RE: Comments on 'Response to Kondolf (2017) "Review of the Sonoita Creek Mitigation Project Proposal for the Proposed Rosemont Copper Mine"' by Water & Earth Technologies, January 2018

Comments on 'Response to Kondolf (2017) "Review of the Sonoita Creek Mitigation Project Proposal for the Proposed Rosemont Copper Mine"' by Water & Earth Technologies, January 2018

G Mathias Kondolf, PhD

Figure 1. Design for artificial channel proposed to replace Sonoita Creek, showing sinuosity of over 1.36 from confluence of Tributary E1 to Tributary E3 (detail from WET Drawing 11, excerpted from my 2017 report).

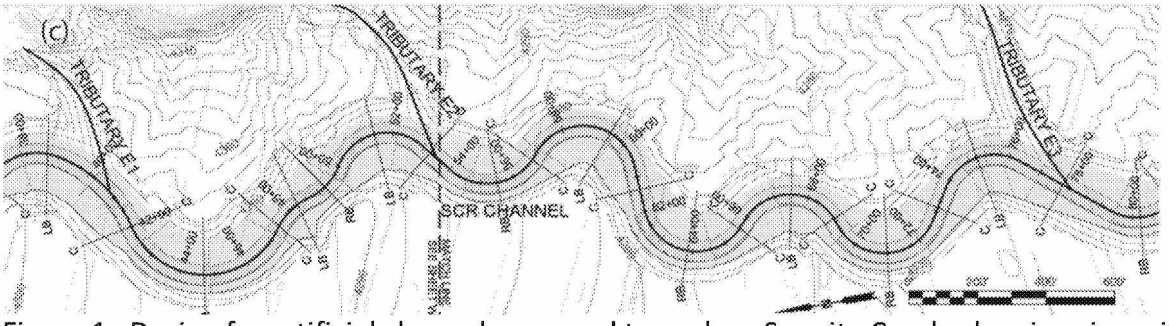
In my 2017 comments, I noted the high sinuosity of the proposed artificial channel (Figure 1), and I pointed out that many stream reconstruction projects elsewhere had failed by the channel cutting across meander bends and creating a straighter channel than what had been constructed. This is a serious concern, especially because the generous credits the proponents claim for the artificial channel are based on the unnaturally large meander bends proposed and the consequently increased length of the channel. I noted that the sinuosity of the Sonoita Creek channel in Rail X Ranch and from the 'reference reach' downstream to the point where Sonoita Creek begins to follow Hwy 82, and the sinuosity of Walnut Gulch on the 'reference reach' identified by WET, were all approximately 1.07, much lower than the sinuosity of the ideally meandering, artificial channel proposed by WET.

In attempting to argue against my critique of the highly sinuous artificial channel proposed, WET (p.11) states that the proposed artificial channel is designed to be flanked by low, easily inundated benches, so that "significant storm events with a flow depth great than 2-feet deep will have a straighter flow path..." Thus, the flow path at higher flows will be straighter, cutting across meander bends. WET introduces a new variable, "dominant sinuosity" of the channel, which WET (p.11) defines as the "sinuosity of flood inundation during the 5-year event," and which will be much lower than the sinuosity of the active channel visible on the plans presented by WET (2017). Introducing this new variable serves to confuse the discussion of sinuosities. It is important to recognize that "dominant sinuosity" is not an accepted term in fluvial geomorphology. Rather, it is a new creation, part of the onslaught of words presented by WET (2018) in its response to my 2017 report. While these words (and their accompanying tables and figures) can initially give an impression of substance, in the end they are mostly irrelevant and fail to support the WET arguments.

More importantly, however, the acknowledgement by WET that high flows will cut across the meander bends supports my point that flood flows are likely to cut across the exaggerated meanders and create a straighter path, eroding the unprotected sediments in the channel banks. The result is likely to be that meander bends will be abandoned and a straighter channel will result, offering far less mitigation acreage than promised for the highly meandering artificial channel proposed for construction.

The proposed design of the artificial channel encourages flood flows to cut across the meander bends, which will almost certainly result in meander cutoffs, which will not be repaired. The straighter channel that results will not have the large mitigation acreage that the proponents seek in the highly sinuous artificial channel they propose.
